Change Order

Change Order No.: 12 CBCL Project No. 241016.00
Date: November 29, 2025
To: Alex Sawyer – Harbour Construction
Contract Name: Mahone Bay Edgewater Street Improvements
Contract No.: 241016.00
Refer To: CCO-08 & Harbour Quotation Document
Copies To: Dylan Heide (Town of Mahone Bay)

Contract Name:	Mahone Bay Edgewater Street Improvements	Contract No.:	241016.00
CCO No.:	08	Date:	October 16, 2025
To:	Alex Sawyer (Harbour Construction)		
Copies To:	Dylan Heide (Town of Mahone Bay)

Park Area Distribution:

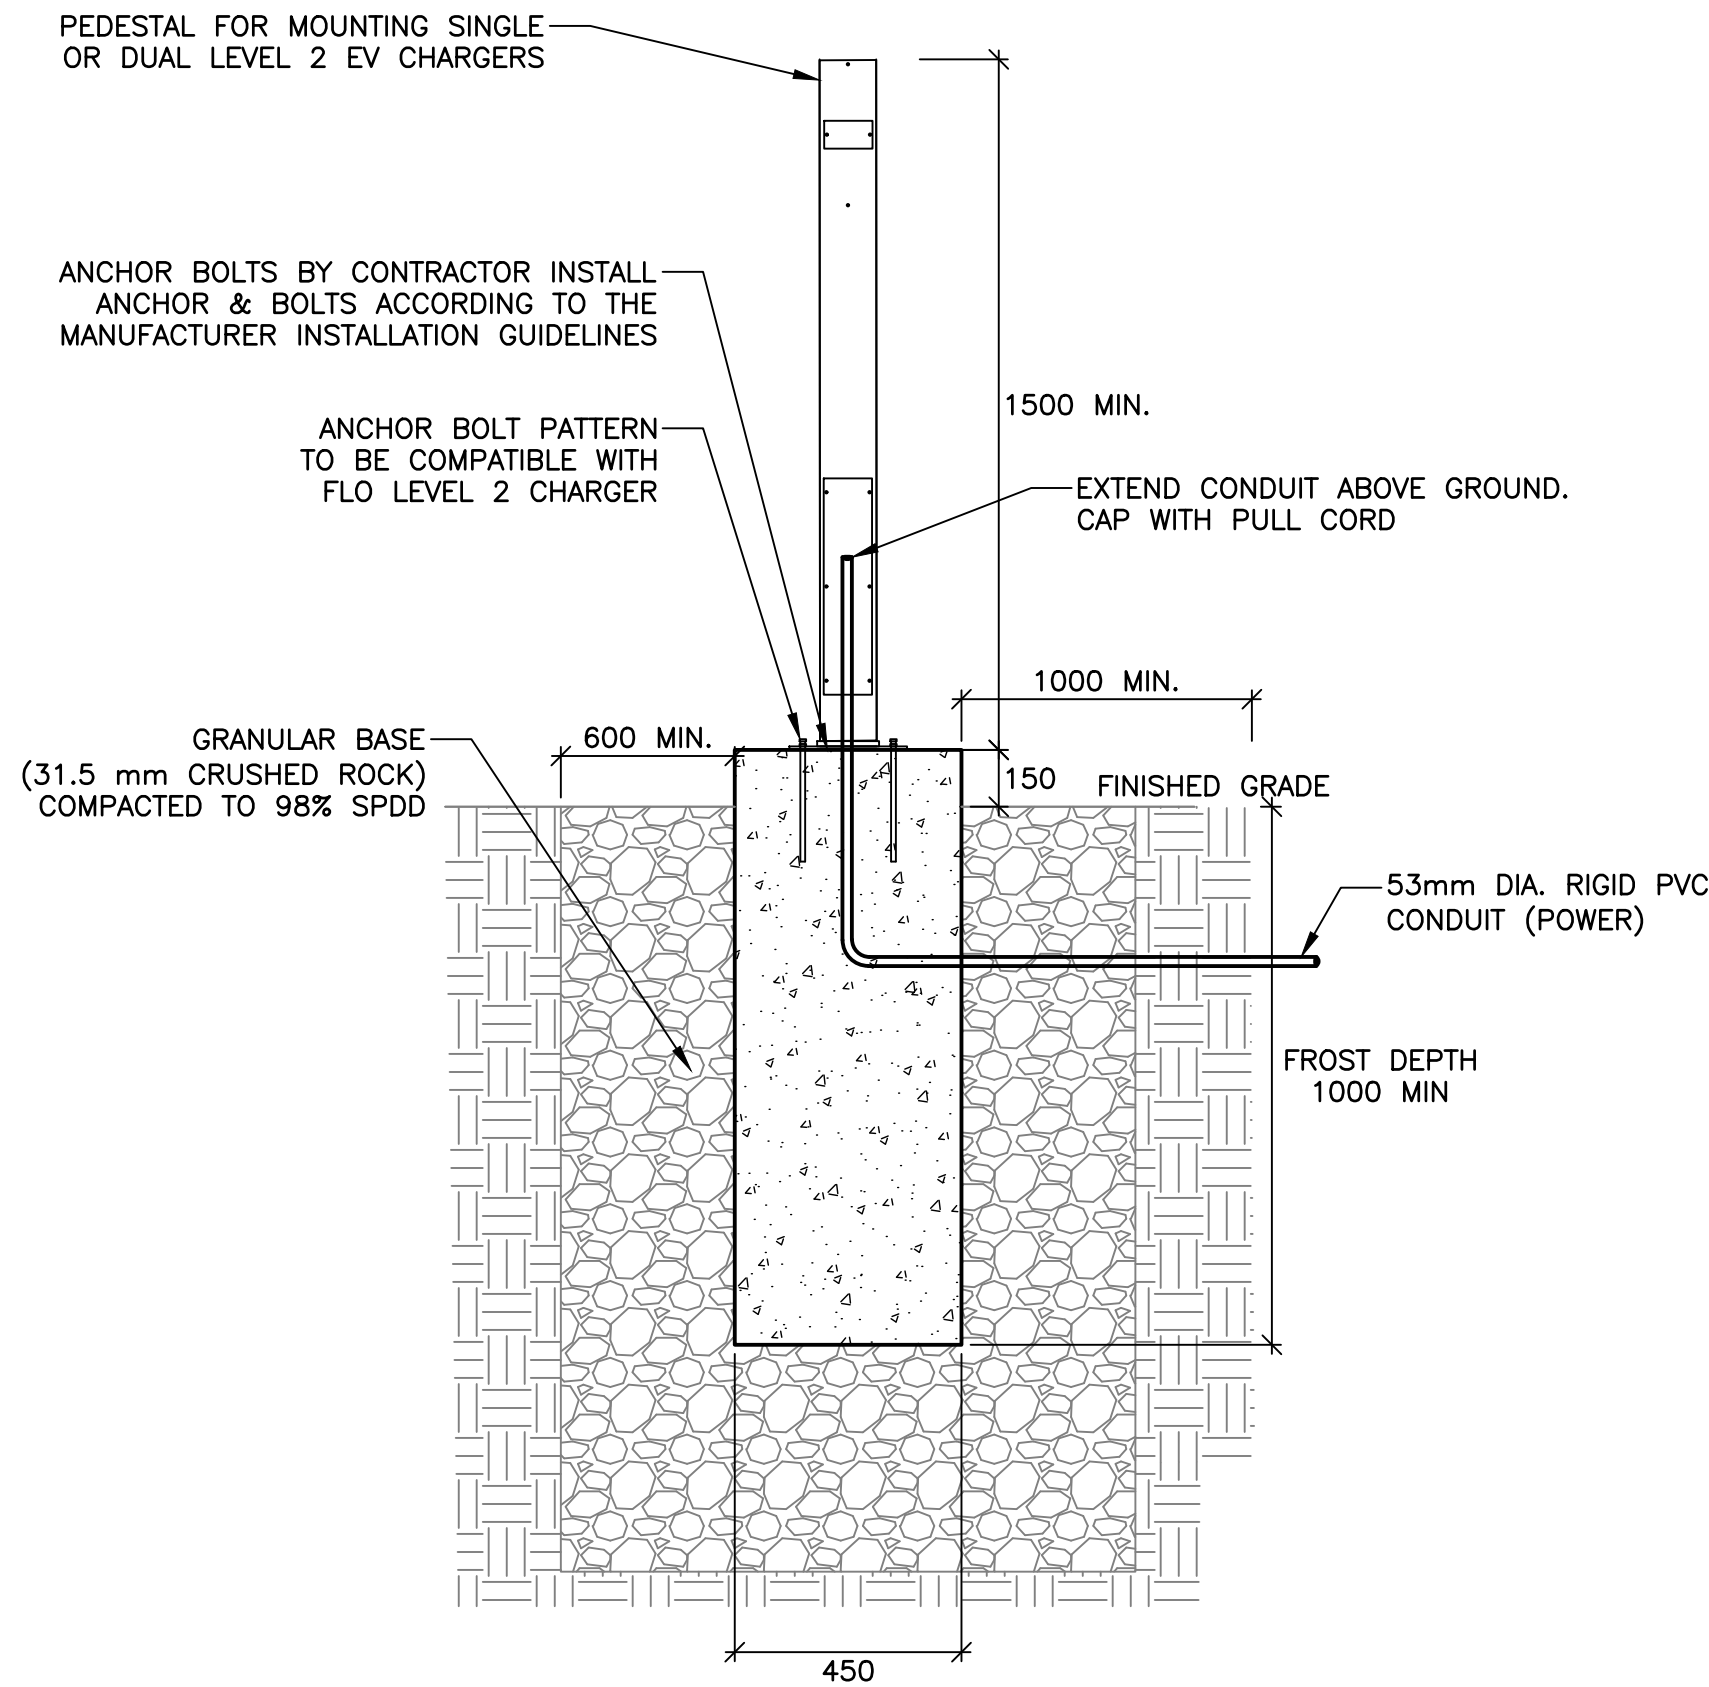
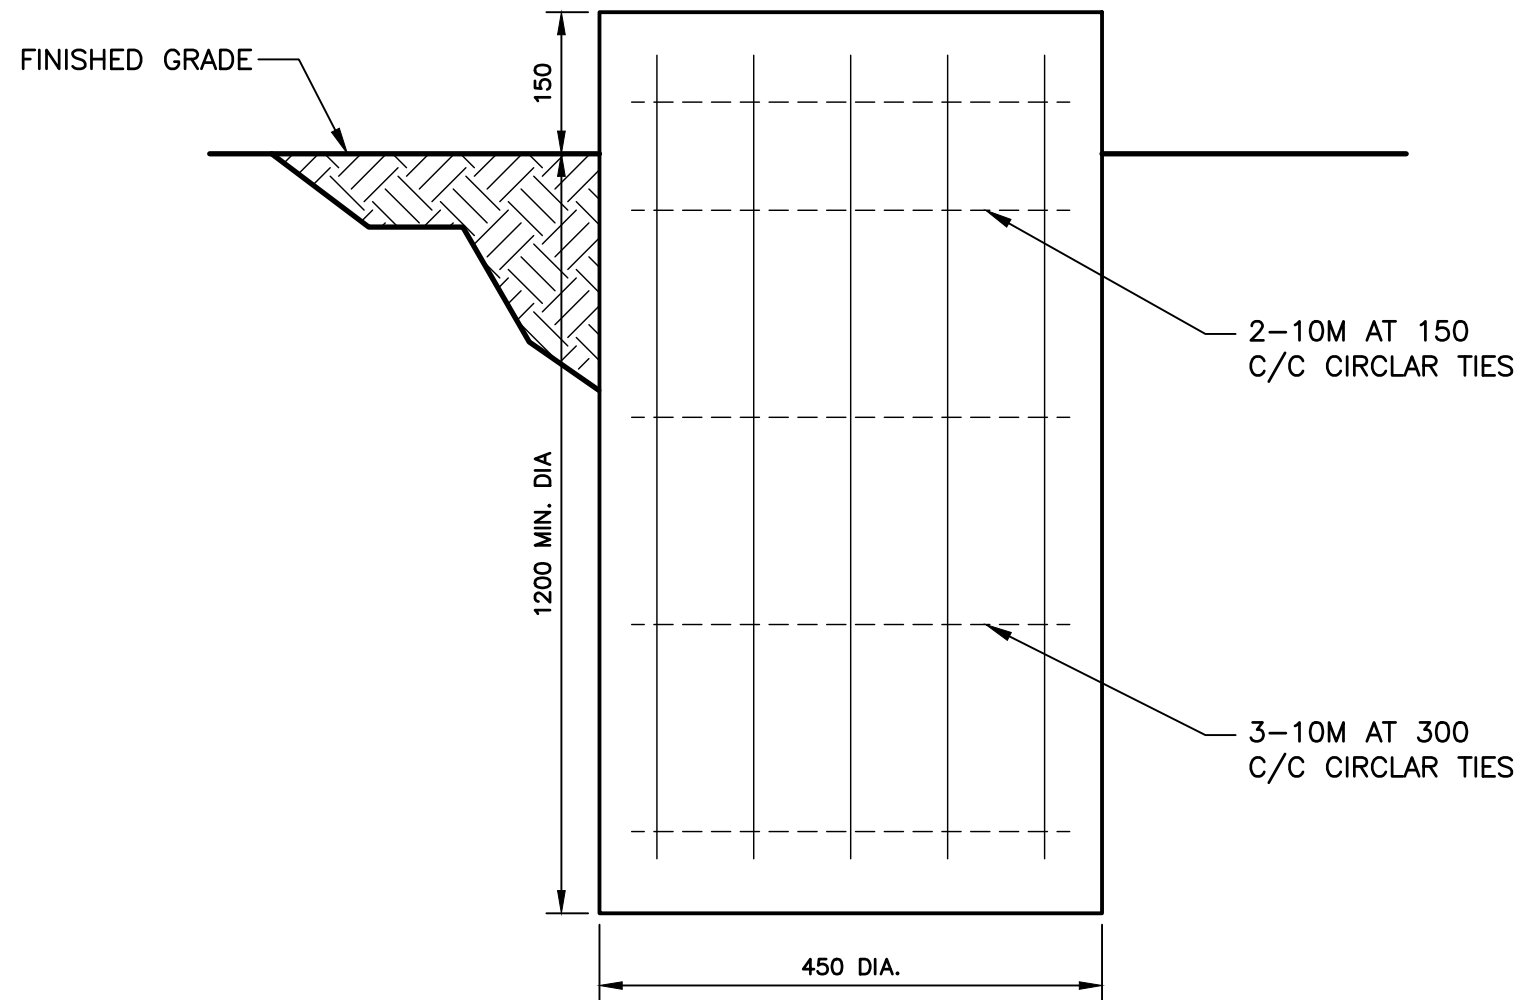
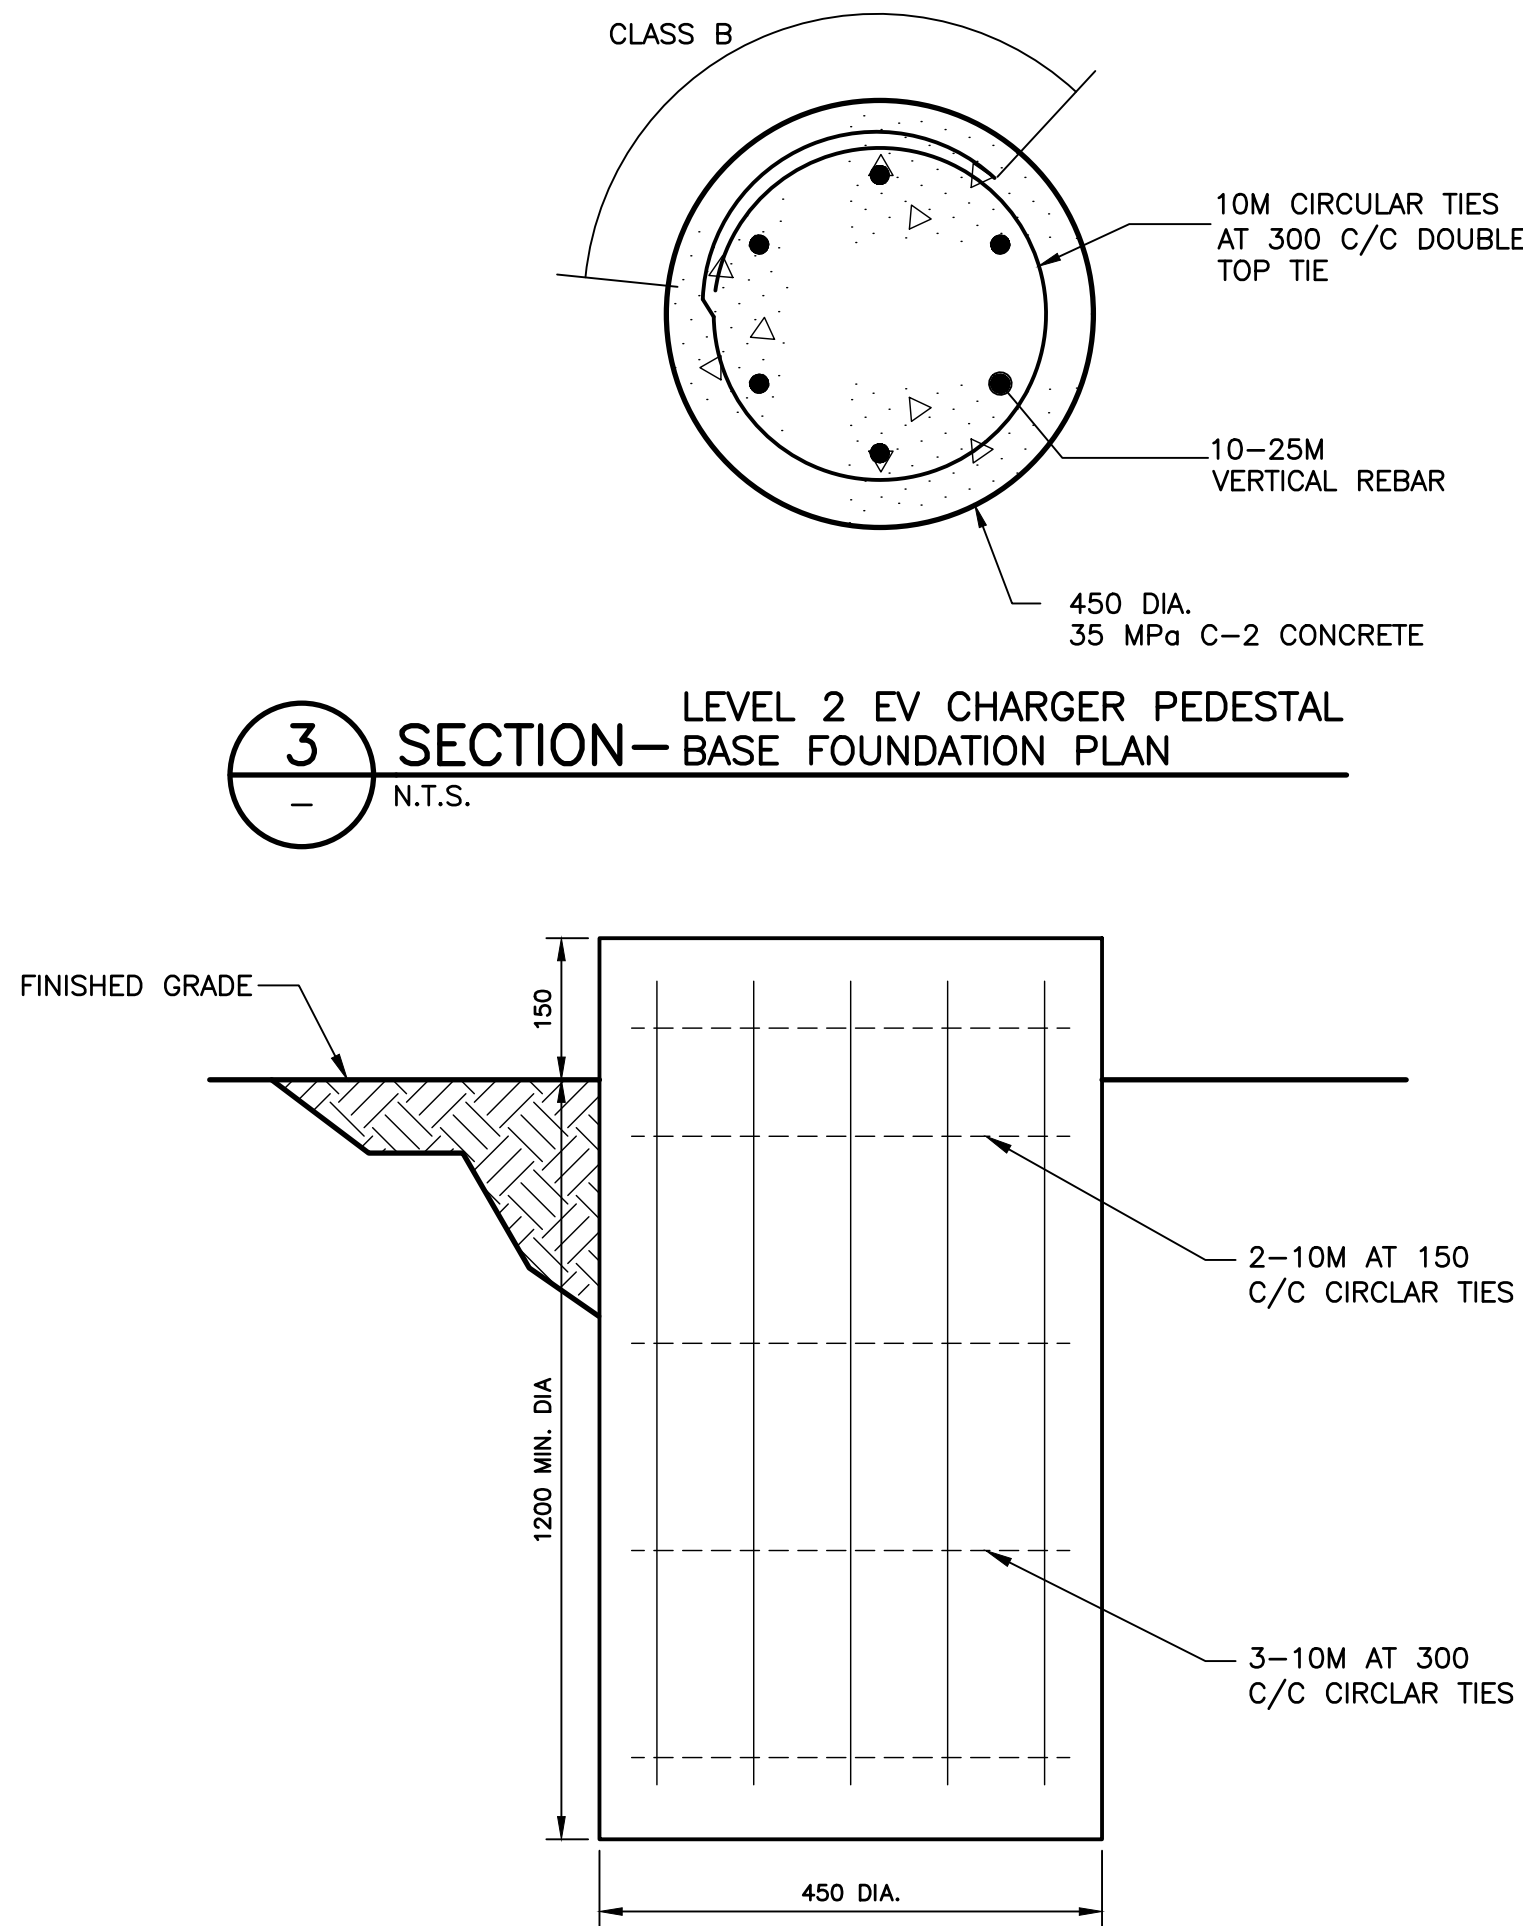
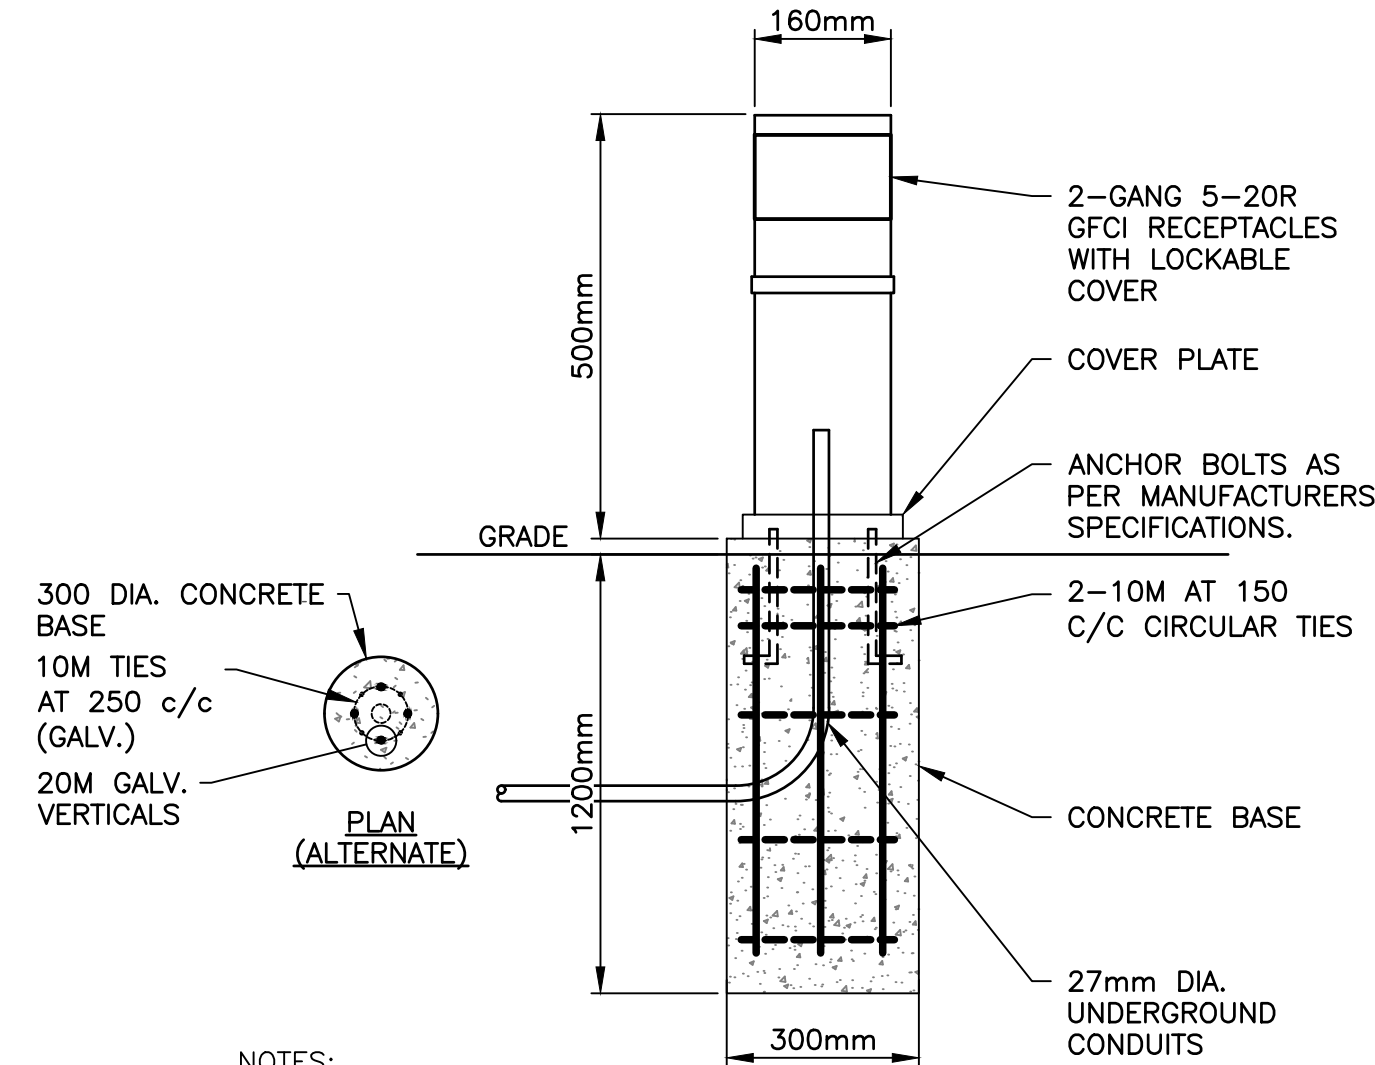
Please provide a lump sum price to complete the following revisions to the Park Area Distribution, refer to Sketch ESK04 and reissued drawings E38-1 and E38-2 attached. Changes from the original scope are as follows:

- Remove the power pedestal for food trucks; remove 15m of secondary to pedestal; remove two (2) bollards.
- Revise location of power pedestal for lighting (Power Pedestal A).
- Replace existing wood post with receptacles (used for Christmas tree power) with new power pedestal (Power Pedestal B).
 - Maintain connection to adjacent light pole (L07) on temporary basis to allow use of pedestal B until pad mount transformers are installed. To include approximately 11m of 27mm secondary.
- Add approximately 43m of 27mm secondary from new service center to new power pedestal A and B.
- Include secondary moles (junctions) in URD01.
- Revise service center per the details on E38-1:
 - Add one (1) meter and two (2) additional panels,
 - Add six (6) receptacles as shown,
 - Other revisions as shown.
 - Wood structure encapsulating service center to be completed by others.
